Subject: McGuire Nuclear Station
Docket Nos. 50-369, 50-370
Relief Request 99-002

SECOND 10-YEAR INTERVAL REQUEST FOR ALTERNATIVE NO. 99-002

Safety-related ASME Section XI Code Class 1 Pressurizer Integrally Welded Attachments (Pressurizer Support Skirt to Lower Head.)

FIG. 1 WELDED ATTACHMENT

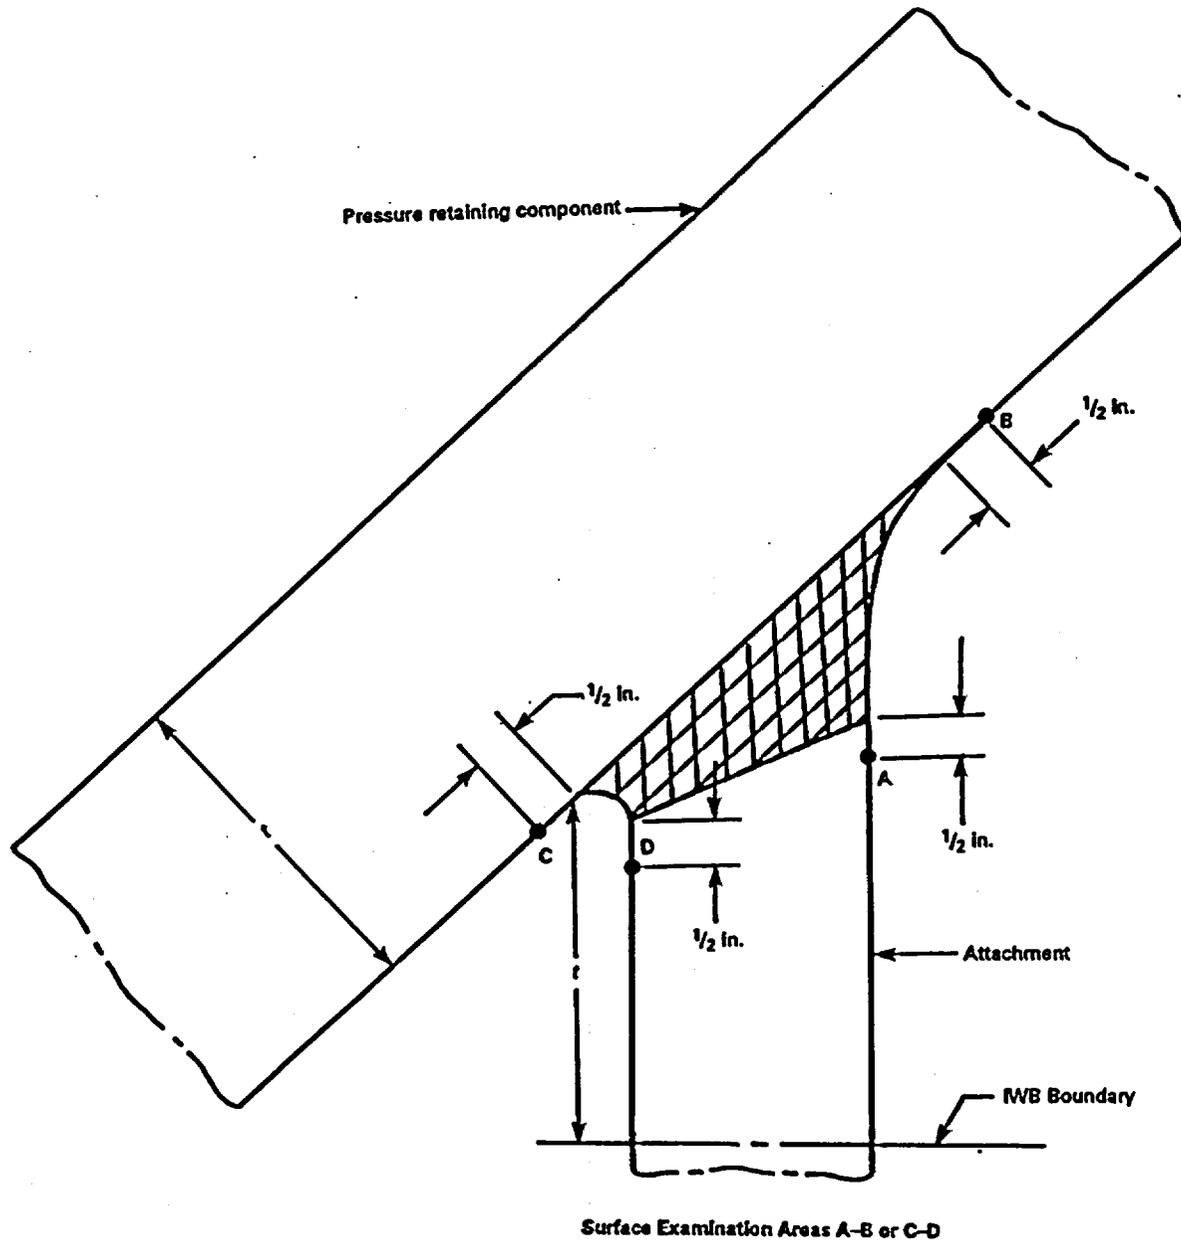
Duke Energy requests approval of Code Case N-323-1 and proposes to apply it as an alternative to the rules for surface examination of the Pressurizer Support Skirt to Lower Head Weld specified in Table IWB-2500-1, Examination Category B-H, Item Number B8.20. Code Case N-323-1 (a) allows " for the configuration shown in Figs. 1 and 2, a surface examination from the accessible side of the attachment weld may be performed". Figure 1 shows the surface examination areas to be (A-B) or (C-D).

The OD surface (surface area A-B) of the weld will be examined by magnetic particle testing. The ID surface (surface area C-D) of the weld will not be examined.

There is inadequate accessibility of the inside surface (surface C-D) of the Pressurizer Support Skirt Weld to perform the required surface examination.
